Drainage Letter/Report

Manley Tract El Paso County, Colorado

April, 2022

El Paso County Project Number Add "VR2310"

Exhibit 2: FEMA FIRM Map

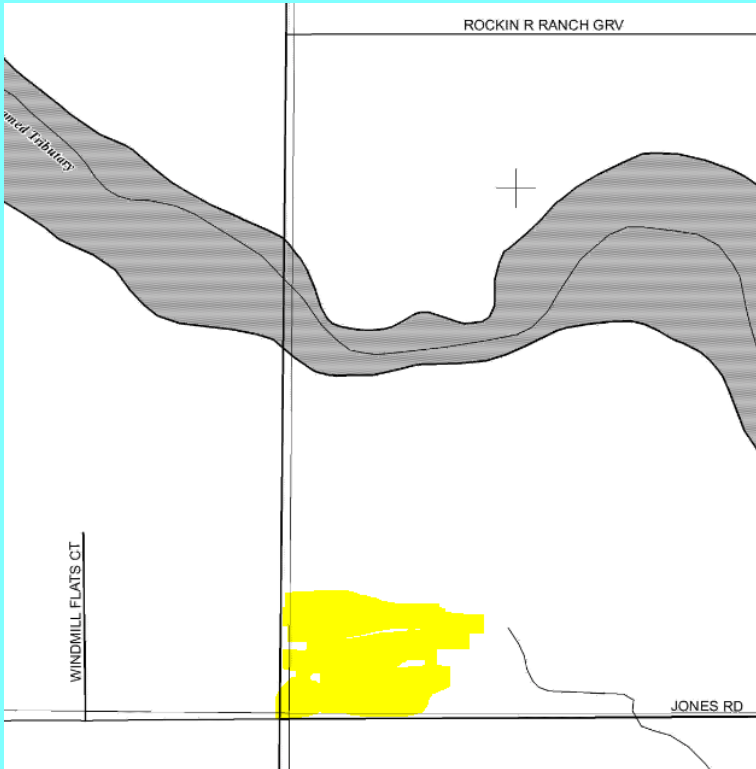
Please verify the FEMA FIRM Map provided on page 18. The map does not appear to be the correct one or most recent FIRM Map. Please see attached images below showing the FIRM Map from FEMA.

See comment from the last page. This does not seem to be the correct FIRM # or map.

Please revise FEMA Map Number to 08041C0568G effective 12/7/2018.

Exhibit 5: Drainage Basin Planning Study Exhibits

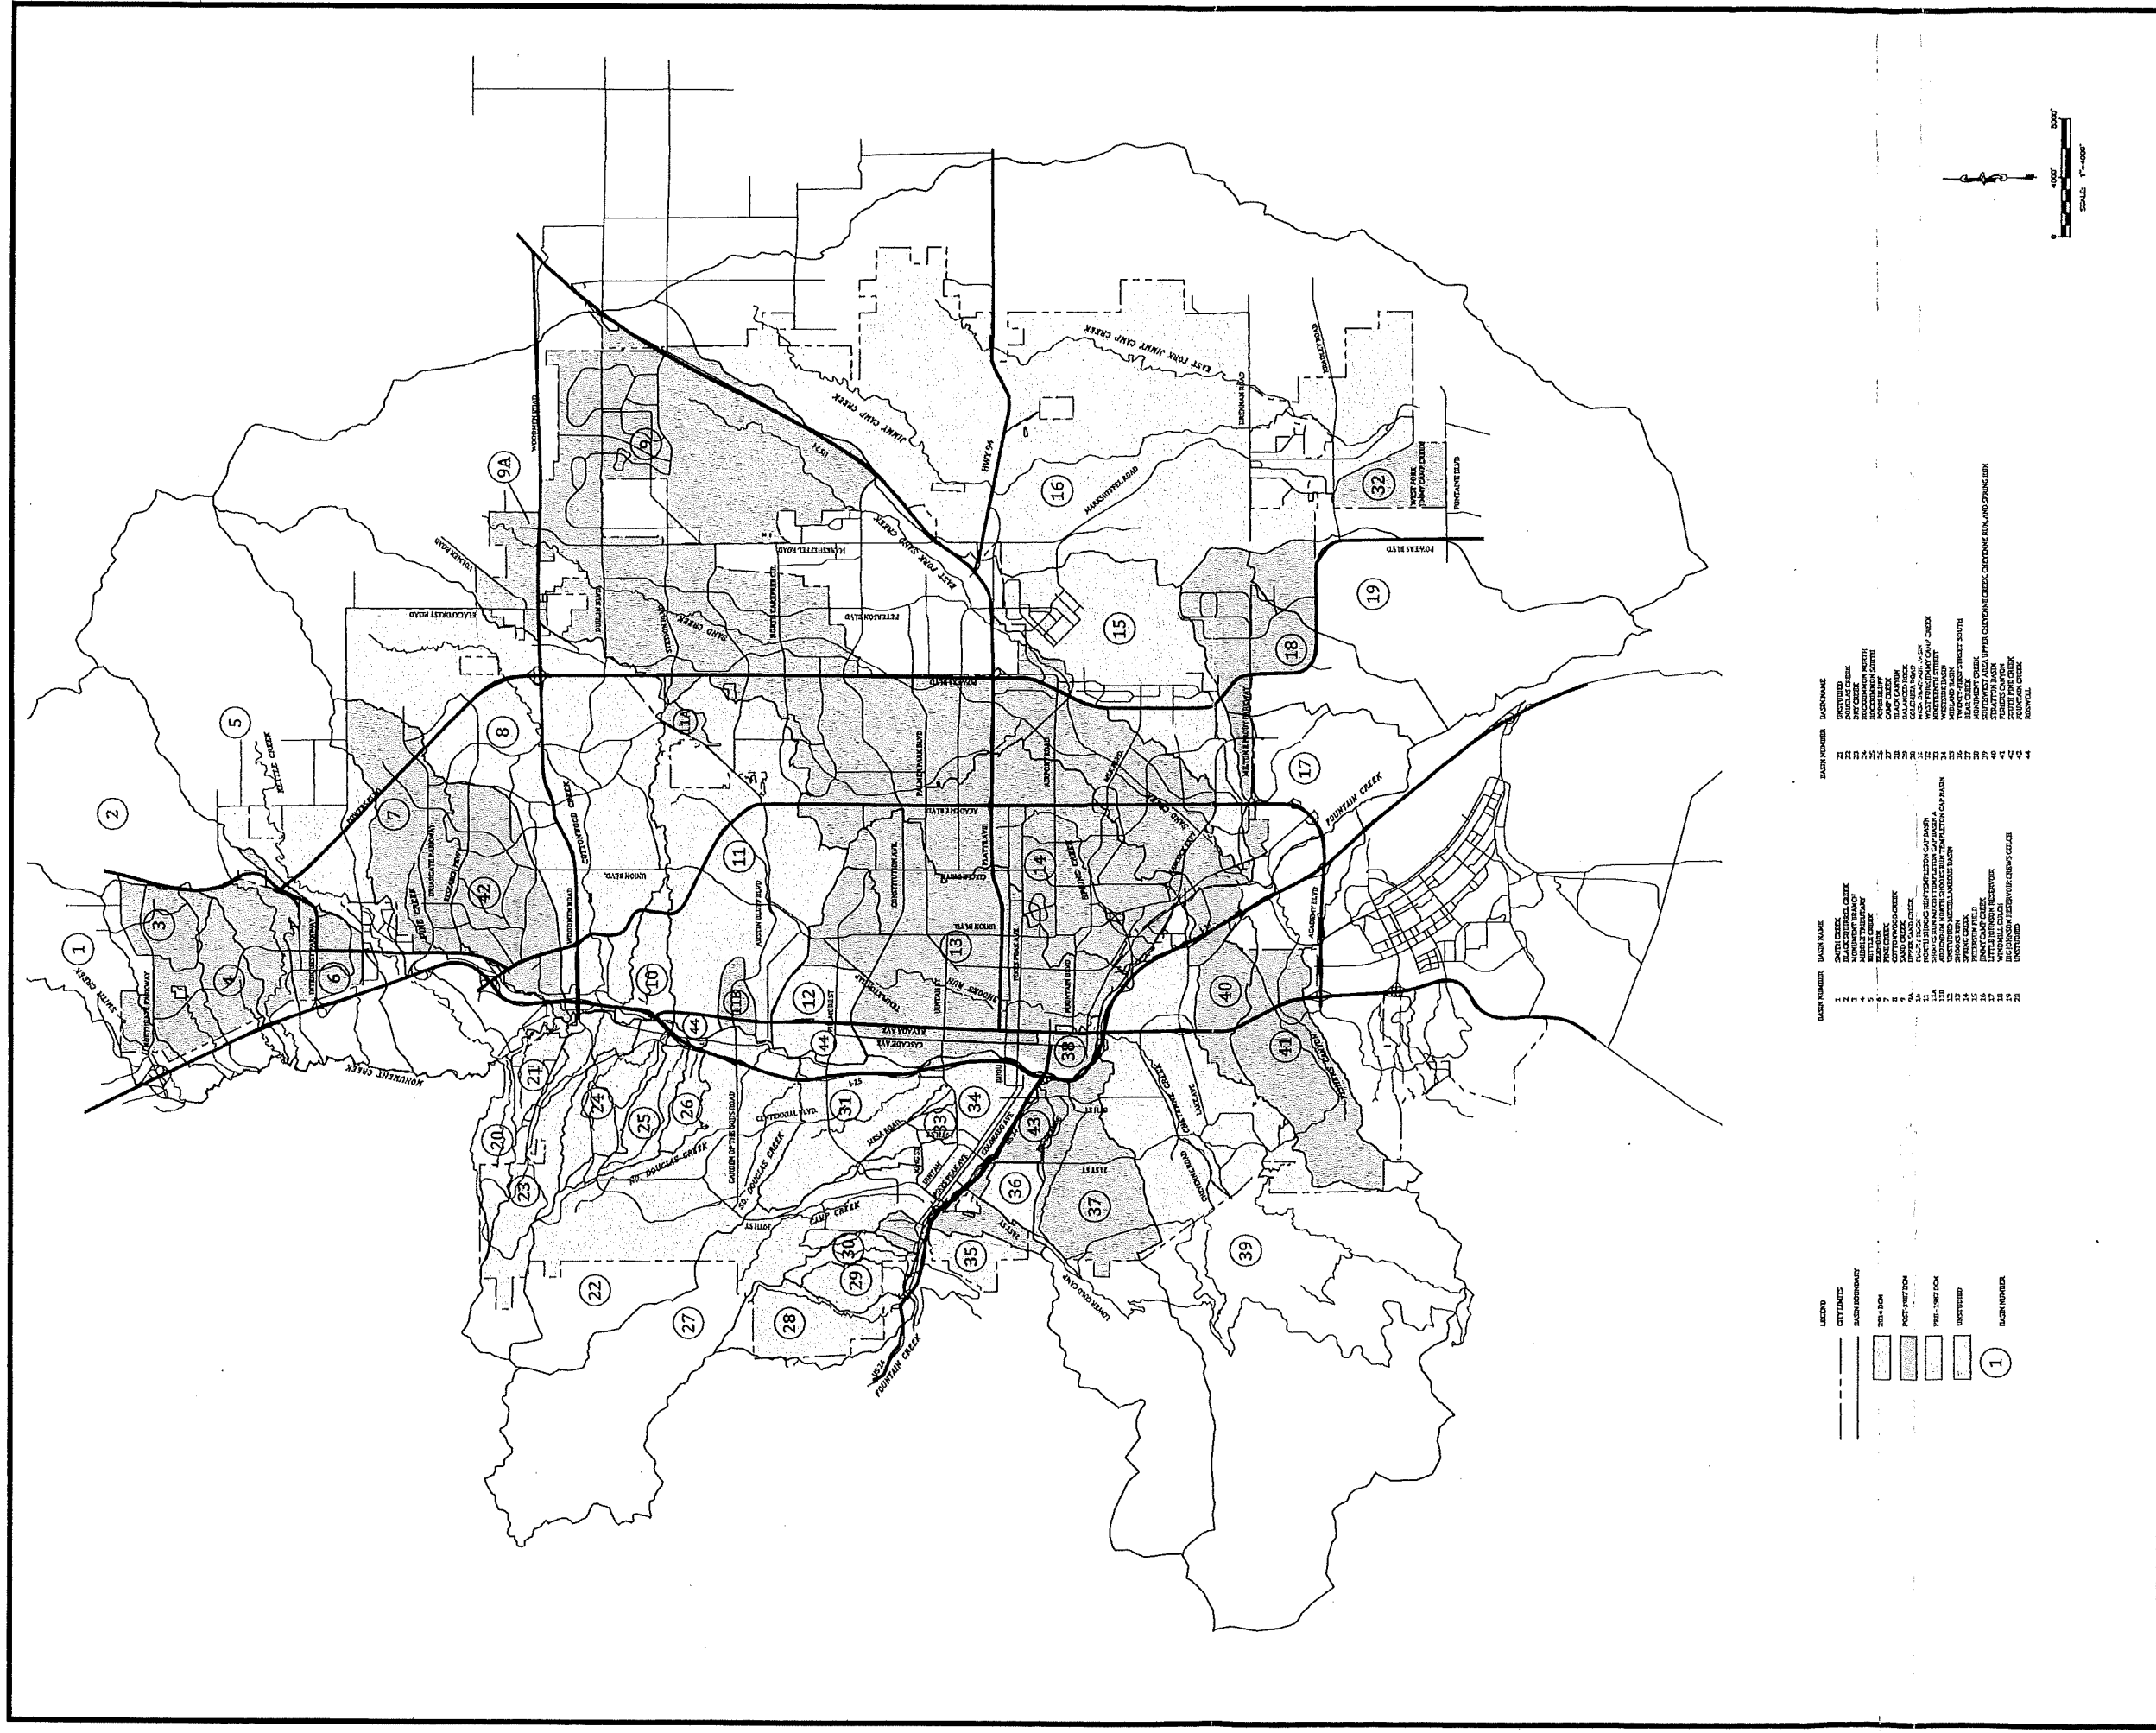
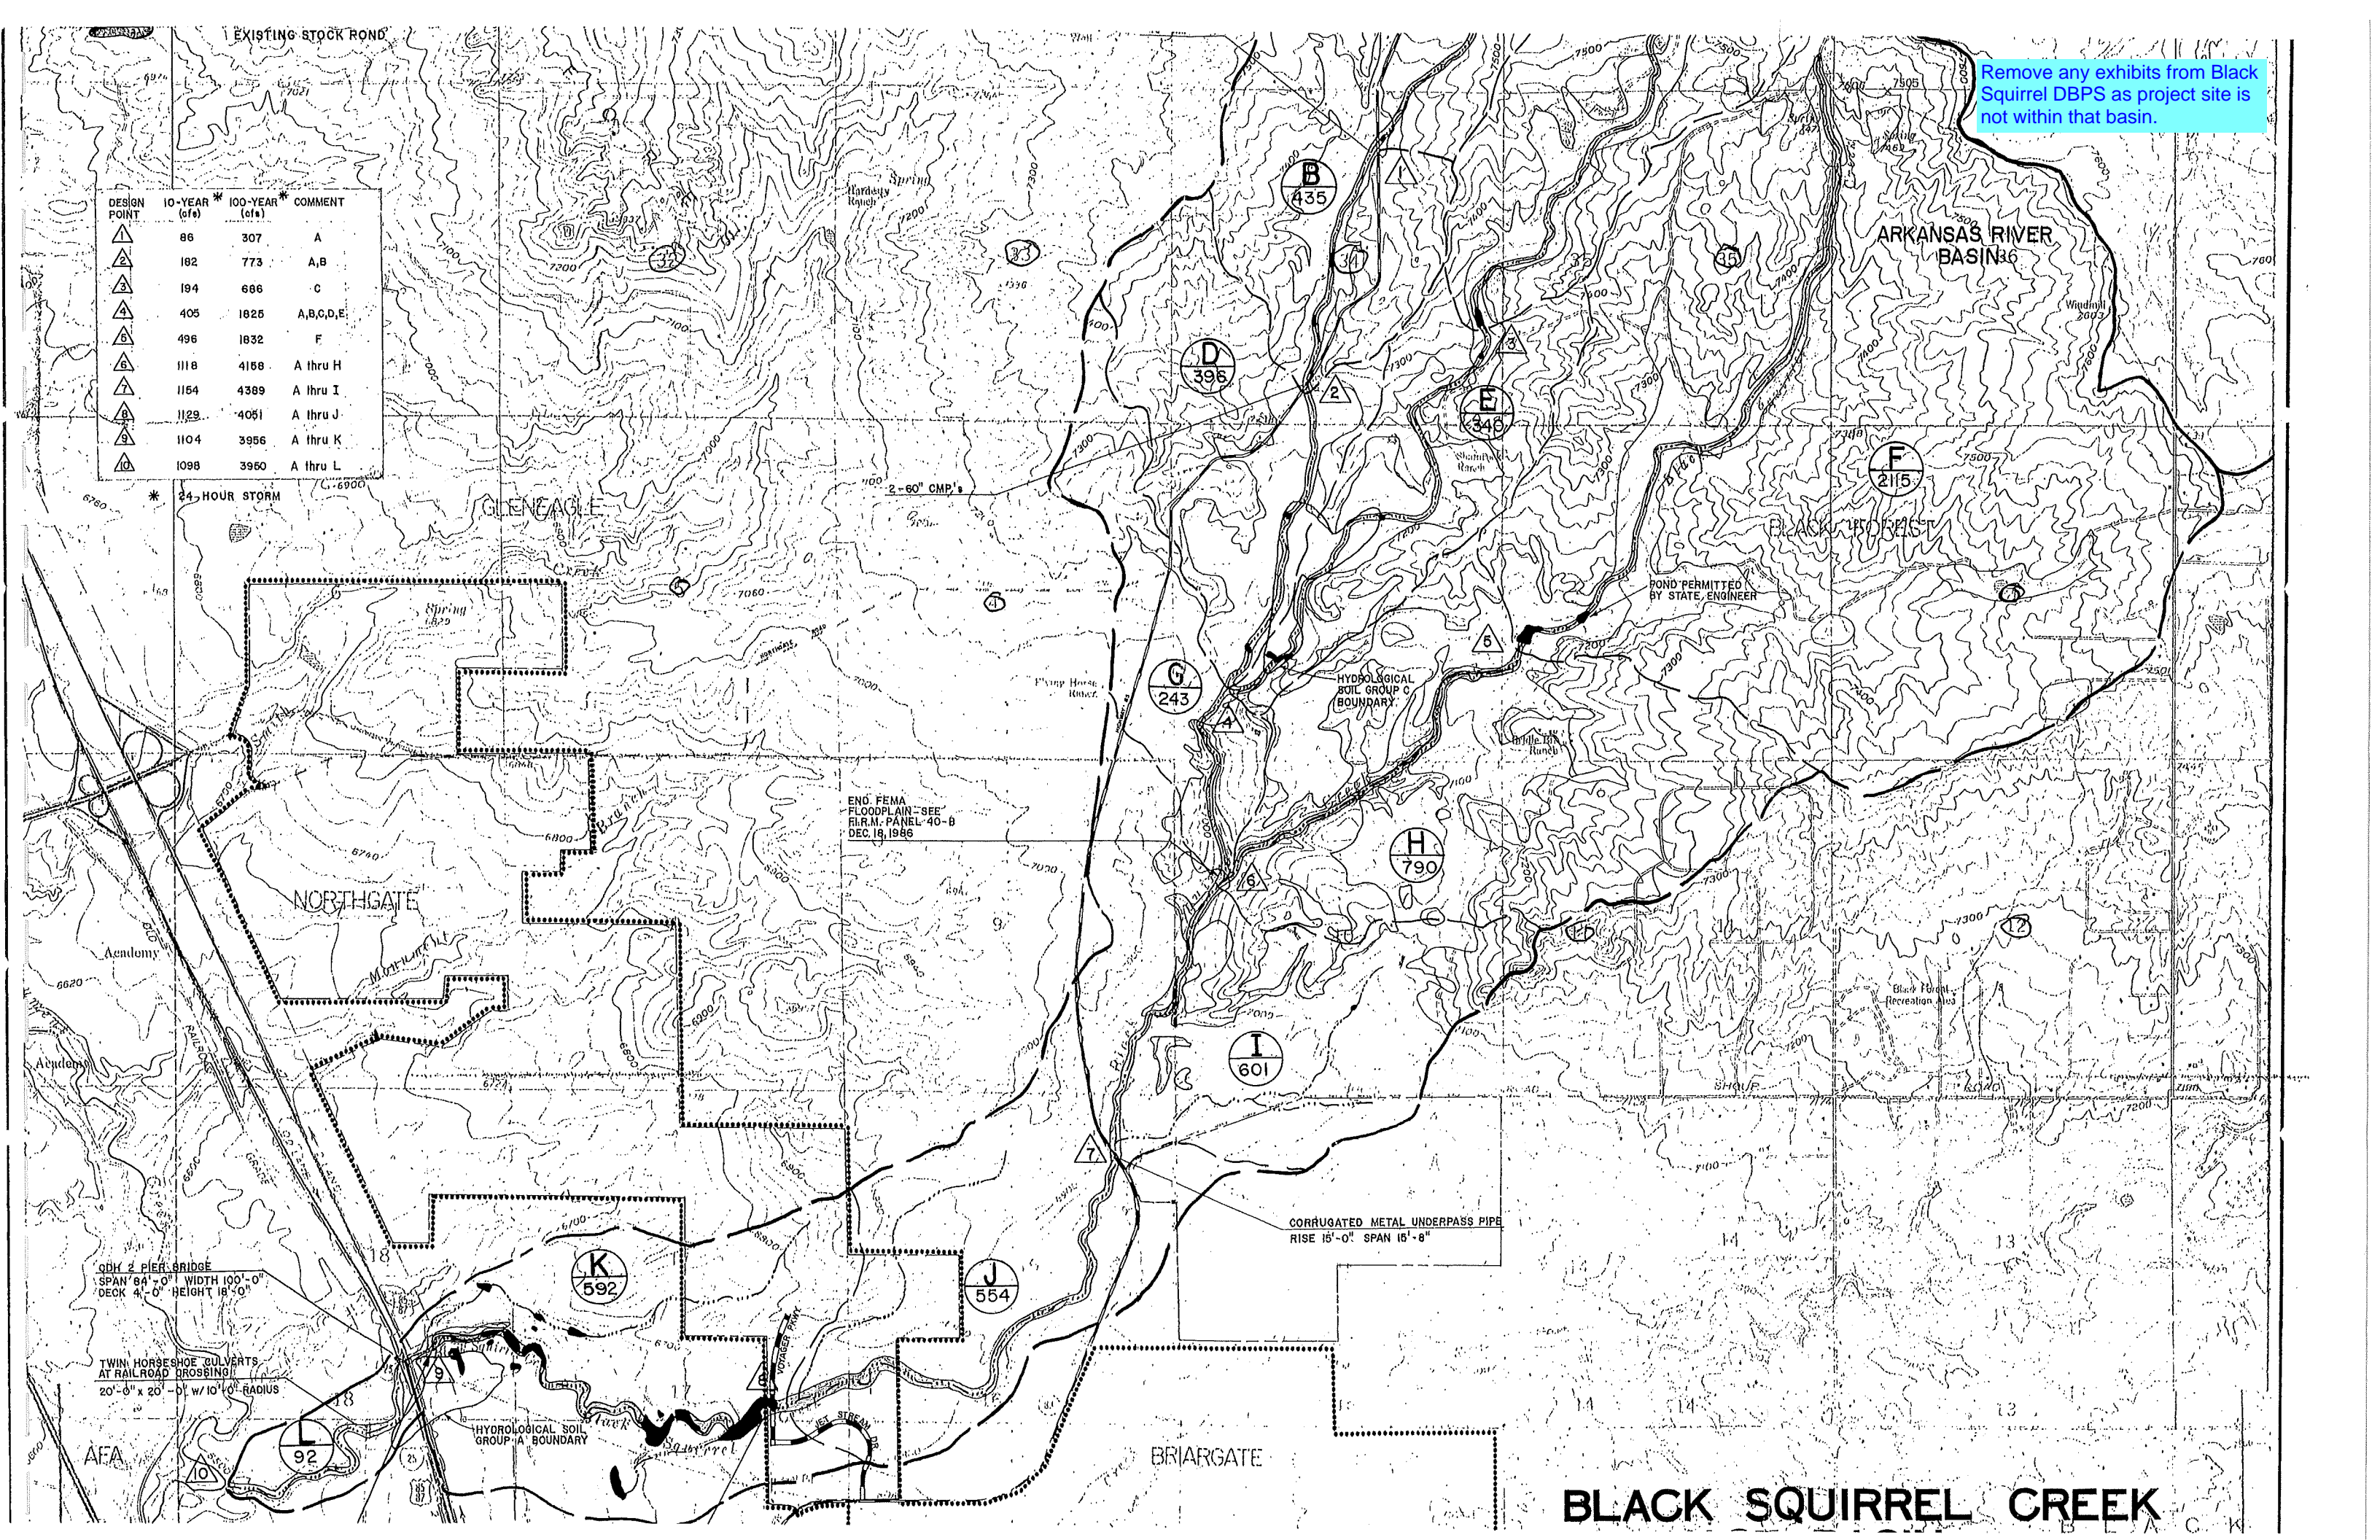
Remove any exhibits from Black Squirrel DBPS as project site is not within that basin.
